Subject: New Drawings Requested - Riverhead Middle School (Liz Hannon) - Due 2/3

Subject: RE: RIVERHEAD MS - BOYS - VL-RVRHB - Release # 5  
From: Jill Hundley <jhundley@vollrathco.com>  
Date: 3/17/2021, 2:15 PM  
To: David Bethel <ddb@davidbethel.com>

RIVERHEAD MS - BOYS - JILL HUNDLEY -  
VL-RVRHB : RIVERHEAD MS - BOYS  
Created 01-29-2020 : 06:23:18.am

—Riverhead Girls Line.jpg

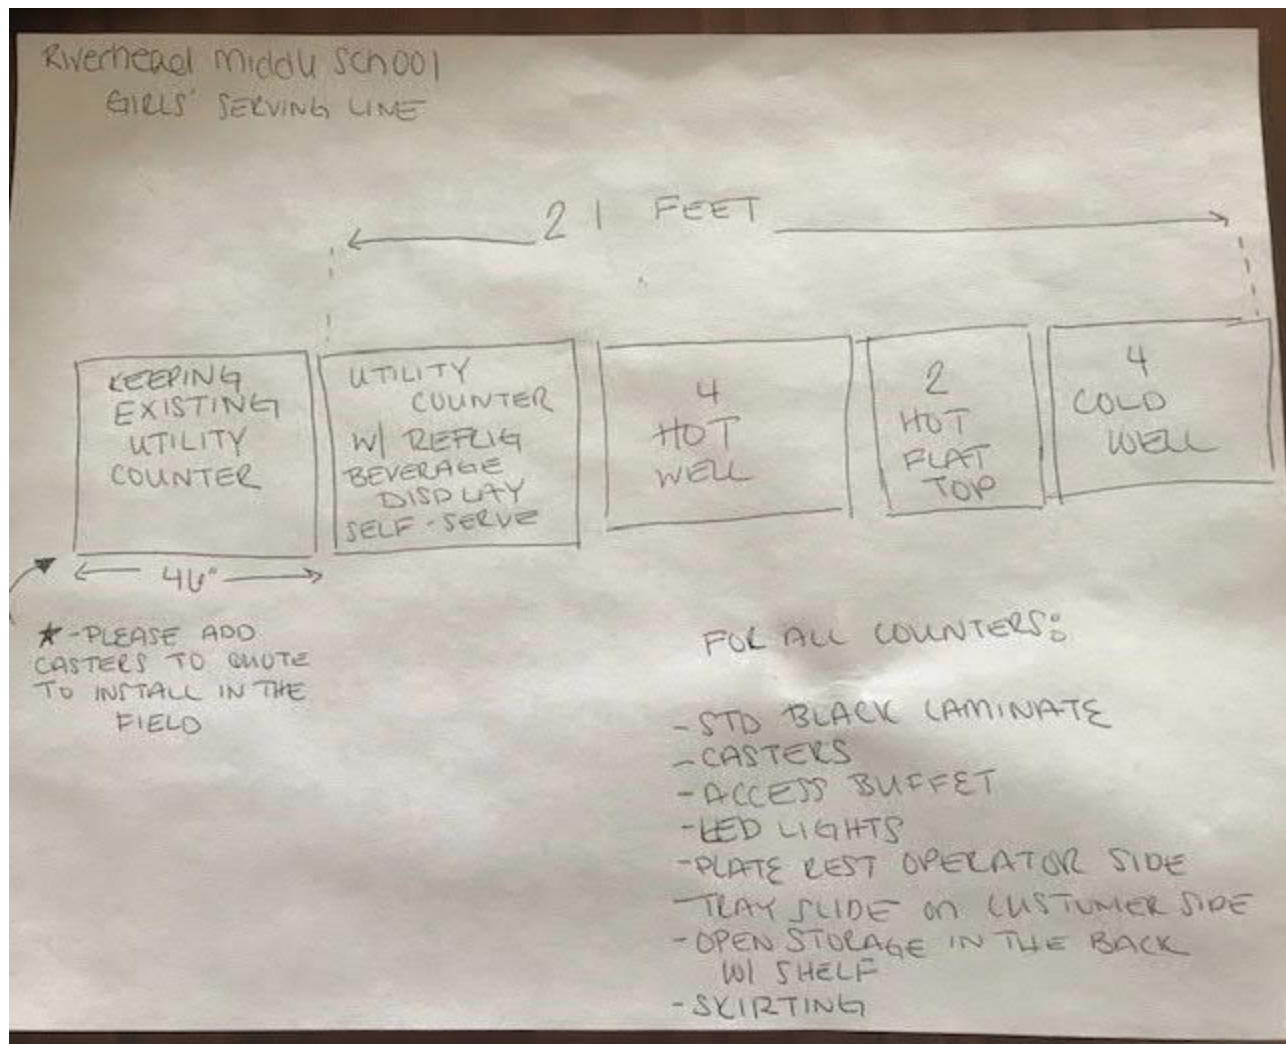
Please complete a drawing package for the project attached, it is two separate serving lines one for boys and one for girls

I have attached the customer provided sketch, make the units match the quote and disregard the OAL listed on the customers sketches
